WRITTEN STATEMENT OF CONDITIONS

The City of North Richland Hills received this plat on January 18, 2023. The Development Review Committee reviewed this plat on January 31, 2022. The following represents the written statement of the conditions for conditional approval of the plat.

MINOR PLAT
LOTS 1 & 2

BEING A REPLAT OF A 2.0 ACRE
TRACT OF LAND SITUATED OUT OF
THE ALEXANDER HOOD SURVEY,
ABSTRACT No. 683, TARRANT
COUNTY
DECEMBER 2022

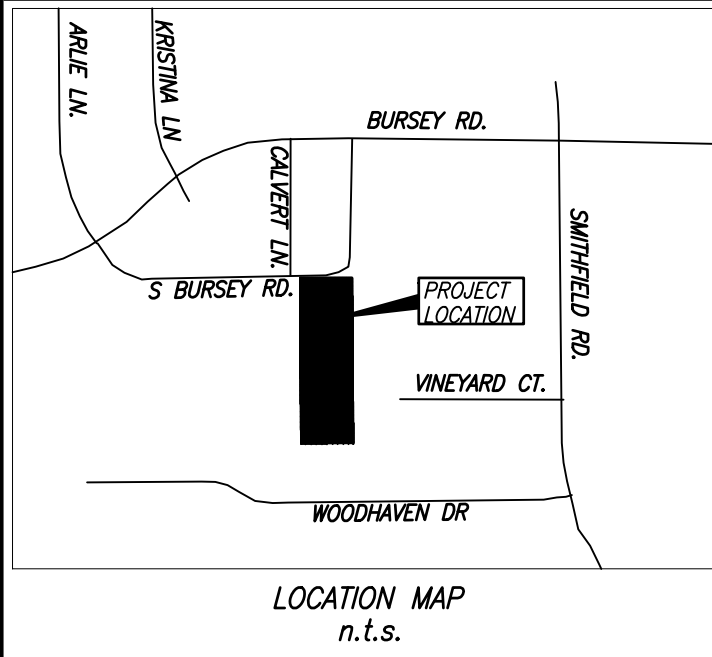
The Development Review Committee (DRC) cannot support the width of the leg on the southern lot as proposed. The DRC would support and recommend approval of a waiver of the 50-foot width for the portion of the leg to provide for a minimum six-foot building setback adjacent to the existing house, provided the remainder of the leg complies with the 50-foot width. The purpose is to ensure that the existing structures can satisfy all building setbacks from the new property lines and prevent the house from becoming nonconforming in terms of setbacks. See exhibit to right as a guide.

A reduction of the width of the leg may be approved only if a waiver is granted by the Planning and Zoning Commission and City Council to this standard. In order to consider a waiver, the applicant must submit a letter stating the grounds for the request and describing the special conditions or circumstances causing hardships that justify the waivers being requested. Additional information is available online at [Subdivision Regulations Section 110-42](#).

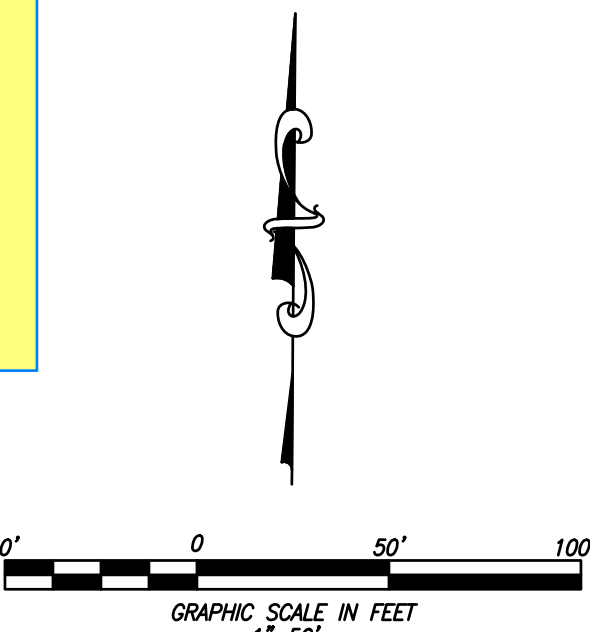
Need to show ROW, setbacks and ALL easements dimensions (existing and proposed)

Show roadway in better detail

Show the property lines, easements, and plat recording information of the lots that are within 100 feet of this property on the opposite side of Bursey Road.

Doesn't appear that either property has access to sewer.

Revise to read: recommend approval of this plat by the City Council

Verify and label the existing right-of-way with established monuments on the opposite side of the street

Remove pavement edge line from drawing

Add a 25-foot front building line to Lot 9

See DRC review letter for comment regarding the southern lot (flag lot) dimensions. As shown, the leg portion of the lot does not comply with minimum lot frontage standards.

Add a 25-foot front building line to Lot 10

Revise to read as follows:

Change the legal description of the property to Lots 9 and 10, Block 1, Oakvale Addition. Update this reference on the drawing, title block, dedication statement, and other relevant instances.

The County clerk recording block may be removed from the drawing. Plats are recorded electronically, and the block is not necessary.

Will need owners, developer and surveyors name, address and phone numbers

- Provide a minimum of two sets of NAD83 State Plane coordinates (GRID, not surface) on the plat perimeter

- Add notes to the drawing as referenced in the review letter

Show the easements on adjacent lots that are within 100 feet of this property.

NOW, THEREFORE, KNOW ALL MEN BY THESE PRESENTS: THAT, Stuart Wayne Threadgold, and Catarina Abigail Threadgold, do hereby adopt this plat designating the hereinabove described real property as Lots 9 and 10, Block 1, Oakvale Addition, an addition to the City of North Richland Hills, Tarrant County, Texas, and do hereby dedicate to the publics' use the streets, alleys, rights-of-way, and any other public areas shown on this plat.
